NRC Resolution of facility comments.

SSES LOC– 26 NRC EXAMINATION SSES POST–EXAMINATION COMMENTS

From the exam analysis and post–exam review with the applicants SSES has identified three written exam questions (SRO 77, SRO 78, and SRO 80) where a change in the answer key is requested. During the exam there were no questions asked by the applicants regarding these three questions. The requested changes to the questions are founded in procedure requirements and the bases are described in detail below. The complete examination analysis is included as part of the submittal package.

INDIVIDUALLY SCRAM RODS

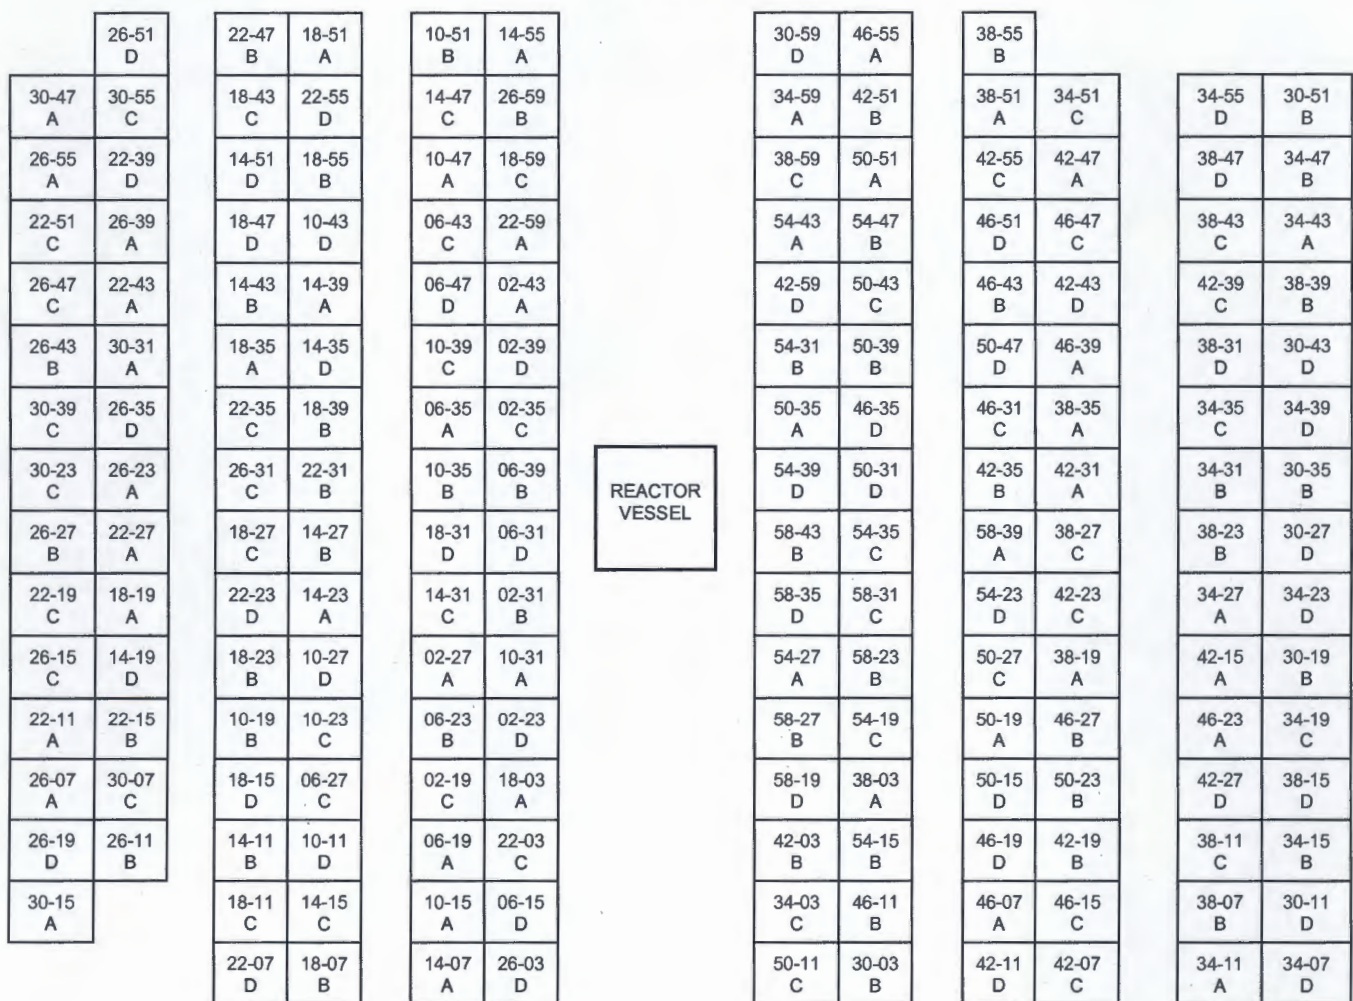
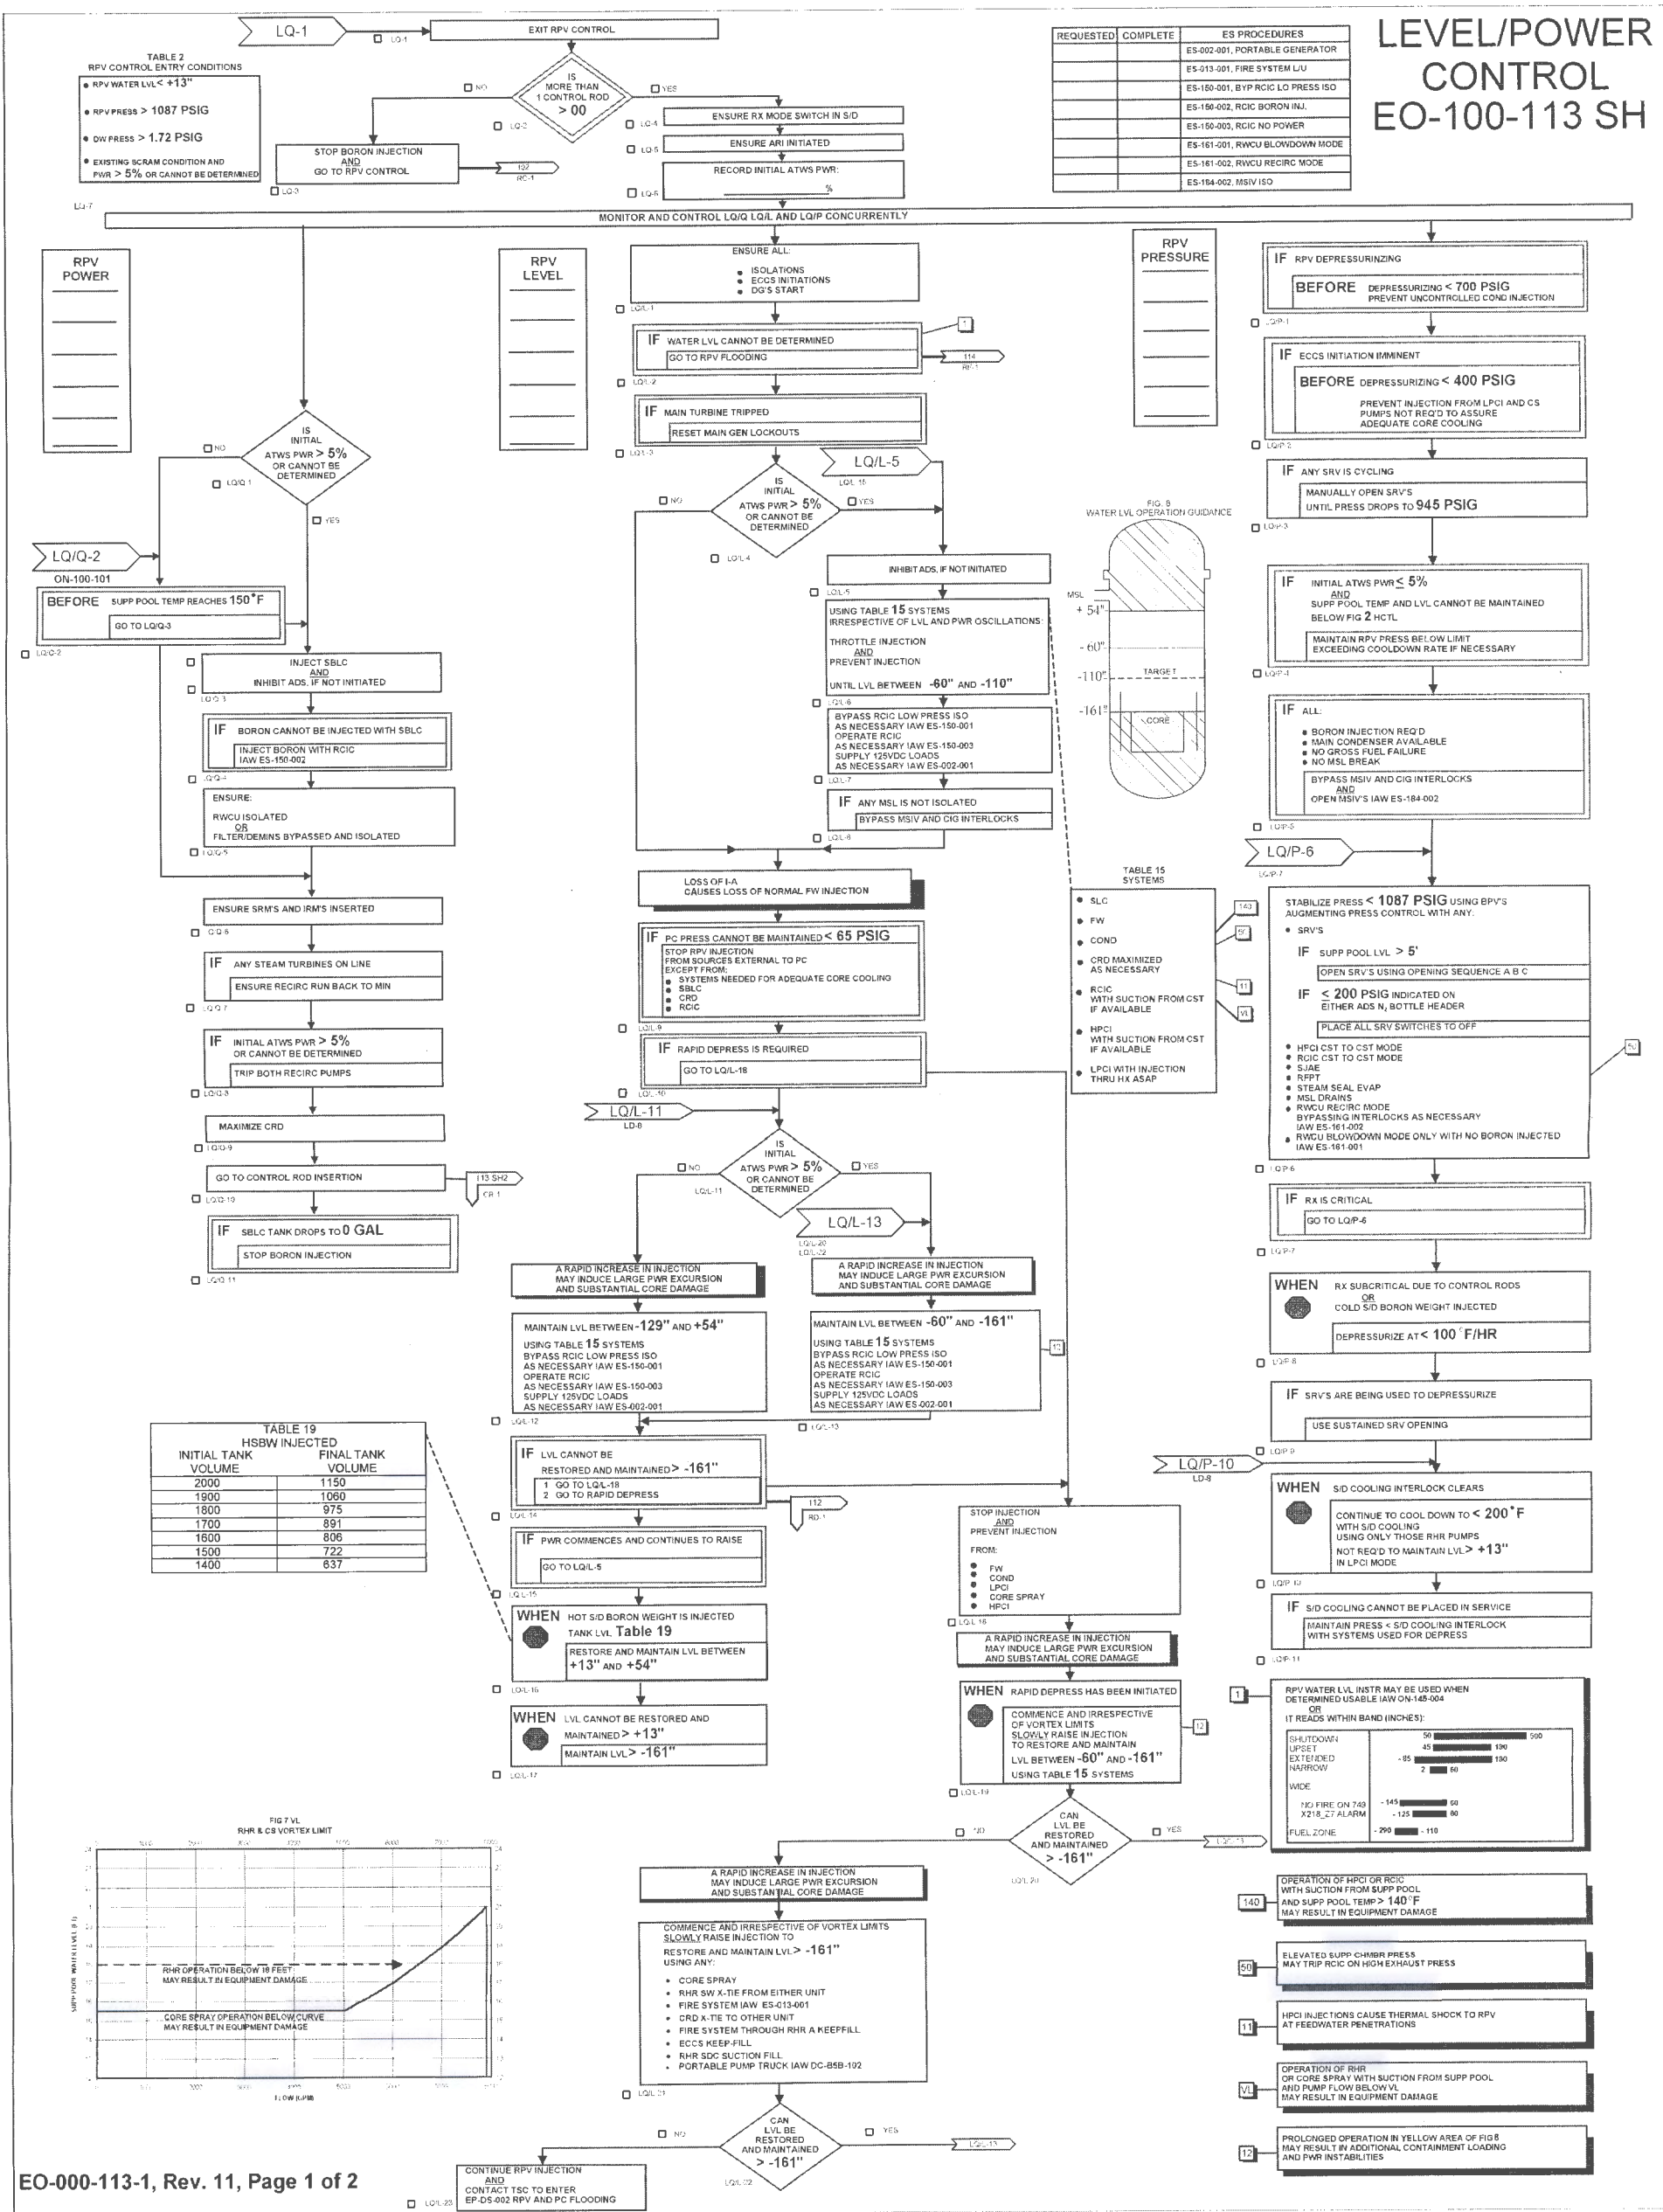
Q80: Facility comment: The question stem presents a combined electric, then hydraulic ATWS. All physically available (given the stem conditions) methods of rod insertion are available with no preferred method. Accept two correct answers.

Selecting response B (*Individually scram control rods in accordance with Attachment A of EO-100-113 Sheet 2*), is also a correct choice based on correct conclusions made by the applicant as follows:

- The method of control rod insertion is an approved method directed by procedure (EO-100-113 SH2, Control Rod Insertion) and all conditions given in step CR-16 are met to proceed as described below and indicated by the information given in the stem.

- The bases for EO-100-113 SH2, Control Rod Insertion, document EO-000-113 step CR 16 for individually scrambling control rods states “Even with an incompletely drained or non-vented scram discharge volume, sufficient capacity may remain in the scram discharge volume to accommodate discharge flow from control rod scrams taken one at a time as opposed to all at once.” The applicant could correctly conclude that this method would be effective based on the information provided in the stem of the question.

- The bases for EO-100-113 SH2, Control Rod Insertion, document EO-000-113 step CR 16 for individually scrambling control rods also states Control rods are individually scrambled until control rods will not insert and it is determined that other methods of inserting control rods would be more effective. Based on the information given in the stem, there is no remaining information for the applicant to determine if another method would be more effective until this method is applied since the initial indication given was that the first method of scrambling was only partially effective.

Given an evaluation of the above criteria SSES recommends accepting responses B and C both as correct answers.

NRC Resolution: Review of EO-100-113 sh 2 indicates that there are preferred methods for an uncomplicated electric or hydraulic ATWS, but all methods are "on the table" for the situation presented in the stem. Review by 6 NRC examiners did not result in one clear correct answer.

Accept two correct answers as proposed.
